FINAL DECISION AND RESPONSE TO COMMENTS
ON PROPOSED CORRECTIVE MEASURES UNDER RCRA SECTION 3008(h)

HONEYWELL INCORPORATED
FORT WASHINGTON, PENNSYLVANIA

FIGURE 2

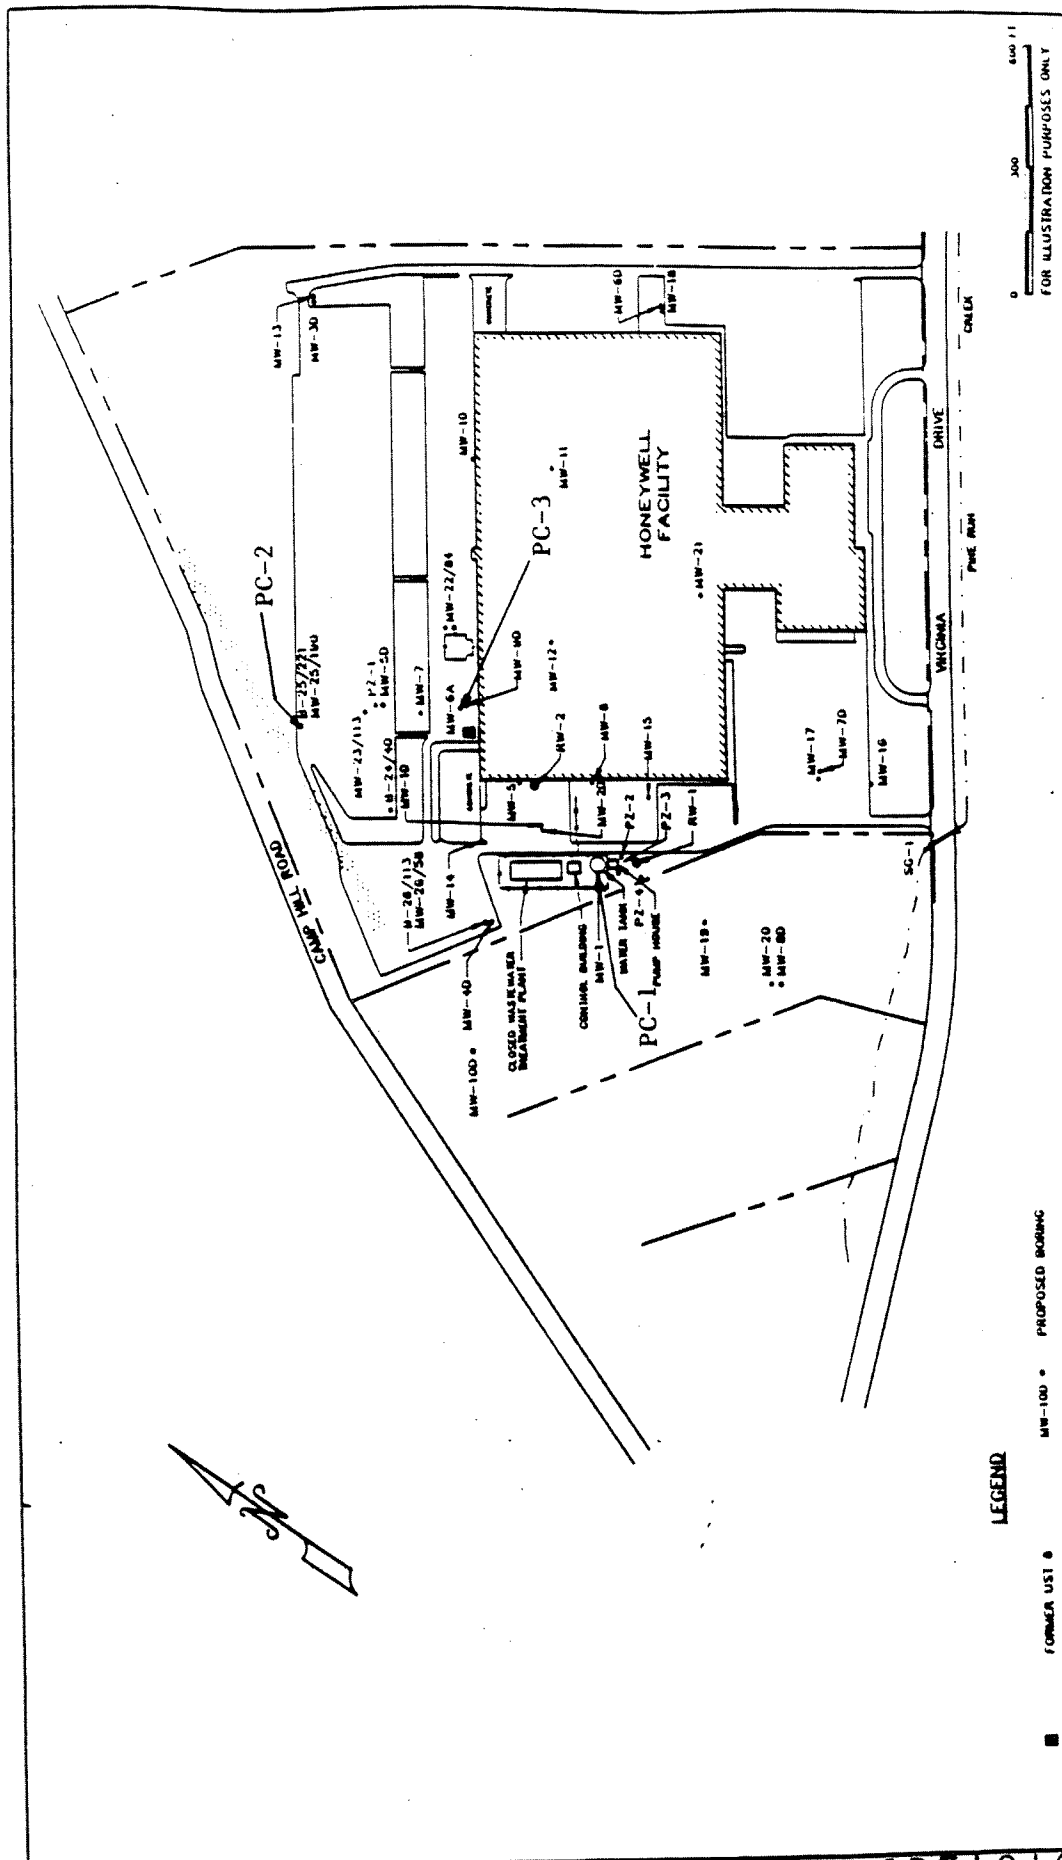
Comment 23 - EPA has only indicated two compliance points that are on the facility property but it appears the contamination plume is migrating farther than the compliance points, how will the plume be monitored past the compliance points?

Shallow part of aquifer
Comment 1 - Honeywell does not agree with the points of compliance MW-1 and MW-25 that EPA has chosen in the SB. Honeywell believes that the points of compliance should be Pine Run Creek and the residential wells along Camp Hill Road. Honeywell projects that a TCE concentration of 6 ppm at MW-1 and MW-25 will cause a resultant concentration of TCE at Pine Run

EPA's Response: The SB was incorrect in indicating two compliance points. There will be three compliance points and they are MW-1, MW-9D and MW-25. In addition to the three compliance points there will be 10 monitoring wells or points, located on and off the Facility, that will be monitored to track the contamination plume.

In considering this comment, and reviewing RFI data, EPA is adding MW-9D as a third Point of Compliance. EPA believes that MW-9D should have been identified in the SB as a Point of Compliance. During the RFI, MW-9D was the location of the highest documented concentration of TCE.
